DATE <u>6/1/18</u>	PROJECT No. <u>Z171</u>
ATTENTION <u>DANA BERNARD</u>	
RE: <u>REGAN PROPERTY LOT 10</u>	
<u>REVISED PERCOLATION</u>	
<u>CERTIFICATION PLAN</u>

From: Bernard, Dana
Sent: Friday, June 01, 2018 11:36 AM
To: John Carney
Subject: 12333 Point Ridge Drive

We need a few corrections on your revised percolation certification plan.

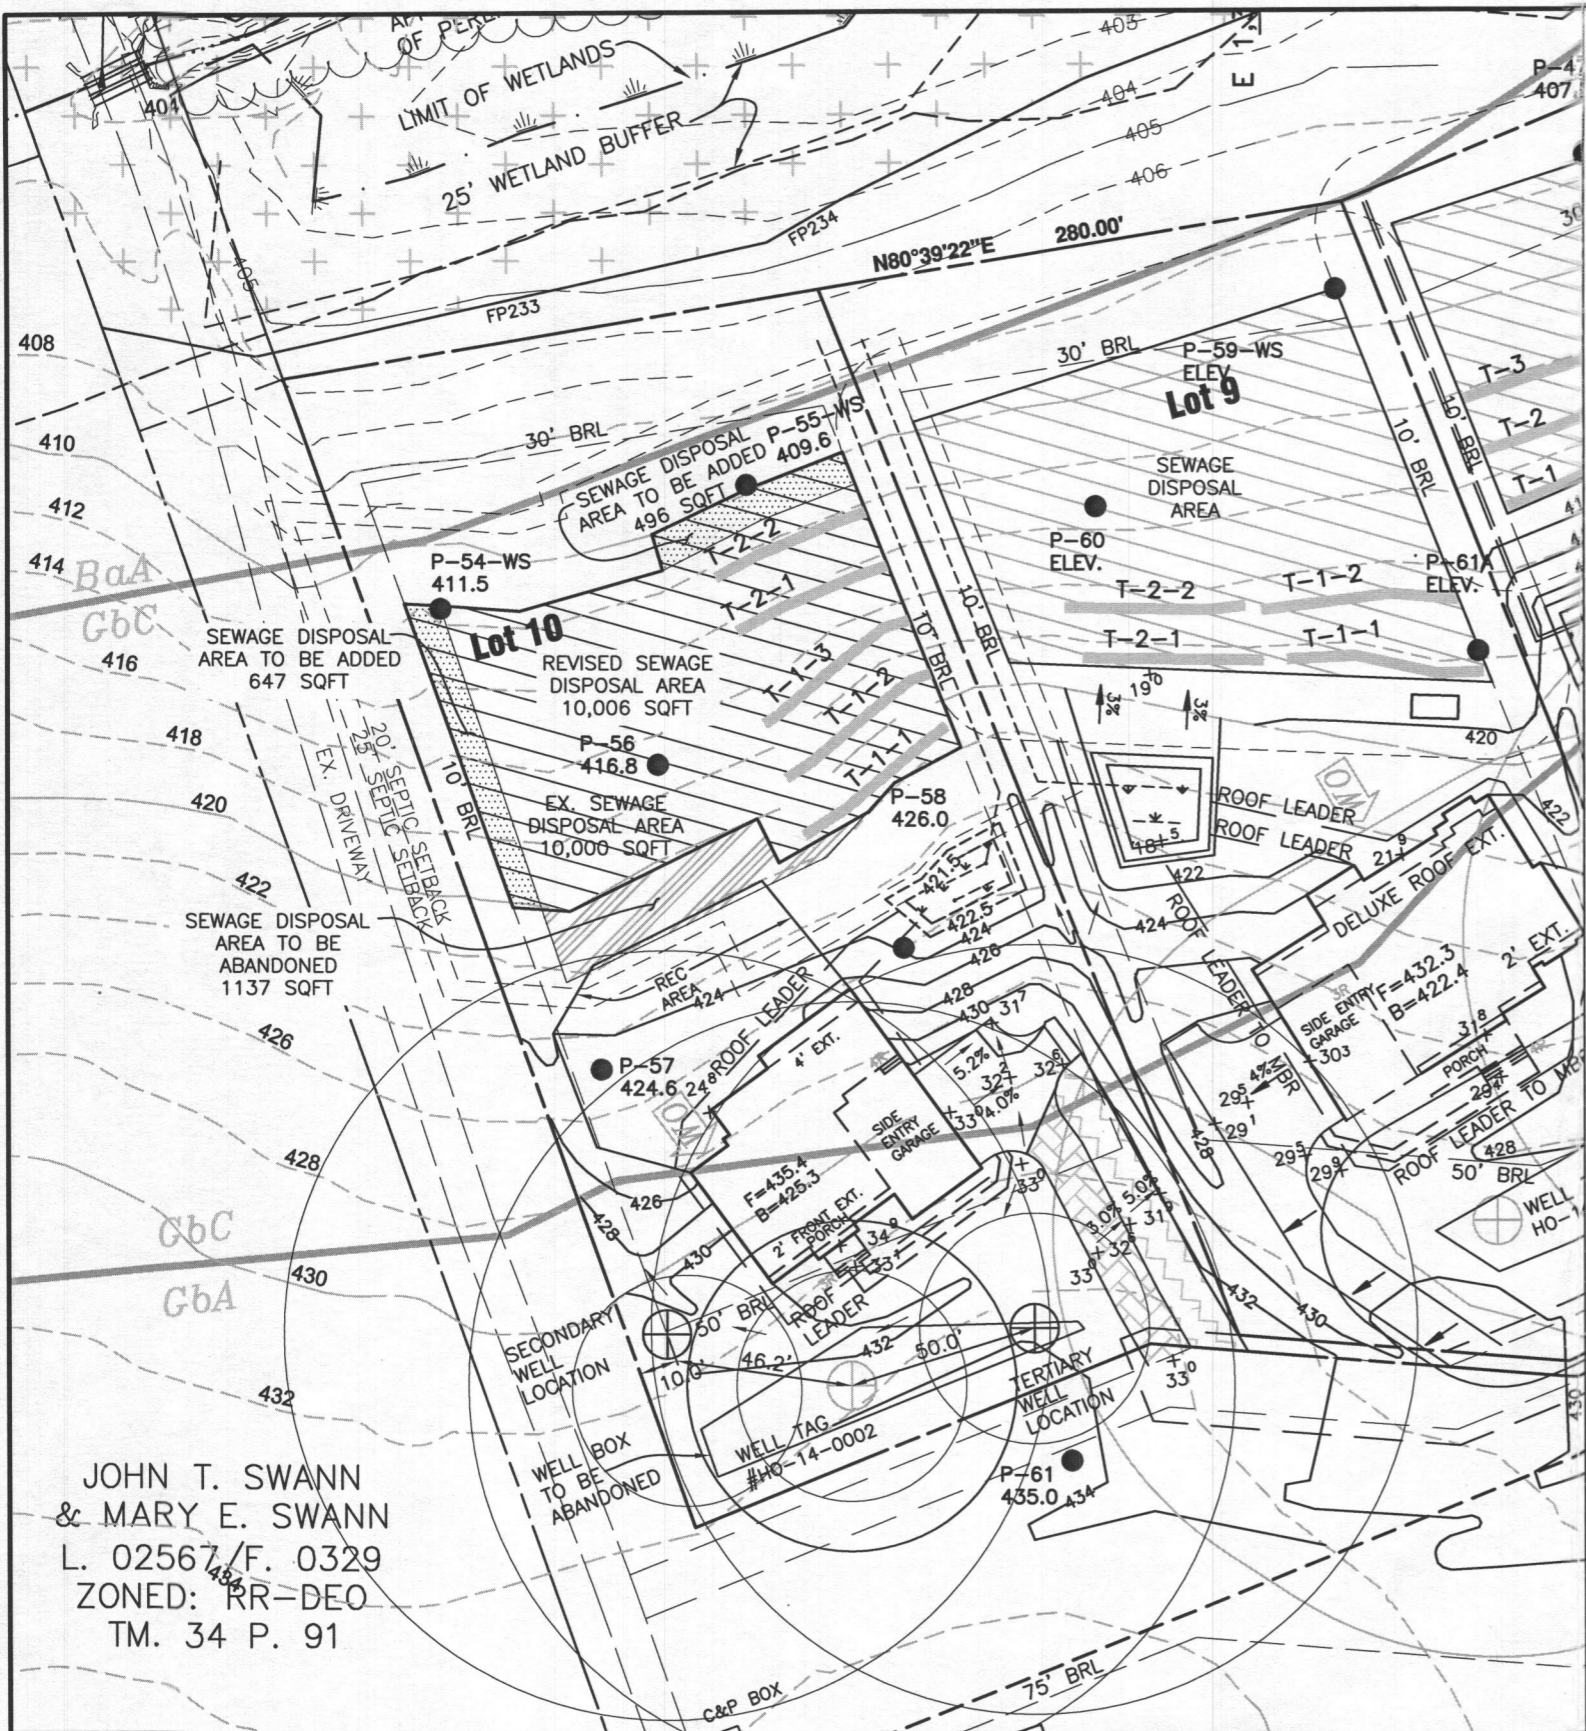
1. The septic tank shown is less than 25 feet away from the rain garden.
2. You don't need to show the tank on the PC , however it must be shown on the OSDS.
